EDF Renewable Energy			Variano	<u>ه، ۱</u> /۸	R-01		
	15445 Innovation Drive			Variance <u>: VAR-01</u> Request No <u>.: Rev-0</u>				
edr	San Diego, CA 92129 858.521.3407			Date Submit: 03/16/2023				
renewables				Date Approved:				
		Agency Received:					_	
				Agency Approval Reference No.:			_	
Request Prepared By: EDFR					Net acreage	affected: NA		
Spread/Location: N/A					Tract No: N/	4		
Location: See attached map					In or within 5	60 feet of a wetland:	🗆 Yes 🛛	No
Alignment Sheet/Sta. No: N/A								
Landowner: BLM					Within 50 fee	et of a water body:	⊥ Yes 🖂	No
Current Land use/Vegetation Cover: I	N/A							
Nearby Features (Water body, T&E H	abitat, Wetland, Noxious We	eds) N/A						
Area, Residence, Resource Site (dista	nce, etc.): N/A							
Variance Level: 🛛 Level 1 🗌 Level	2 🗌 Level 3 (To be assigned	d by Design	ated Representative)					
Variance Form: 🗌 Permit 🛛 Plan/	Procedure 🗌 Specification	n Drawing	Mitigation Measure	Ot	her:

Desert Quartzite Solar Variance 1

Proposed Action – Temporary Gate Along Project's Access Road

Figure 1.Chain and Concrete Block Location.

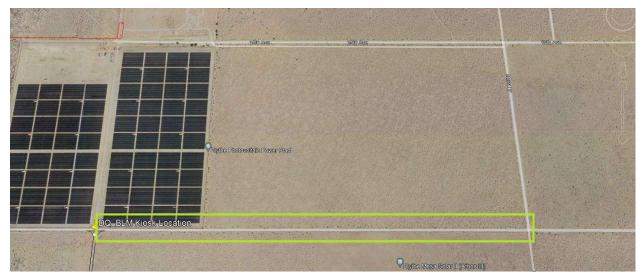
VAR-1 proposes to install a temporary gate along the access road to the Project site just south of the 16th Avenue/Seeley Avenue intersection (**Attachment B**).

VAR-1 proposes to install concrete blocks, also known as "deadmen", on both sides of the access road within the road shoulder. The concrete blocks would be stacked two-blocks high for added height (**Attachment C**). A chain would span the distance of the access road connecting the concrete blocks and serving as a temporary gate across the access road. The chain would be locked at the end of the working day to dissuade delivery drivers from making after-hours deliveries and driving down the 2-mile access road. This variance is proposed as a safety measure to prevent delivery drivers from potentially parking and staging alongside the access road and main access gate after hours.
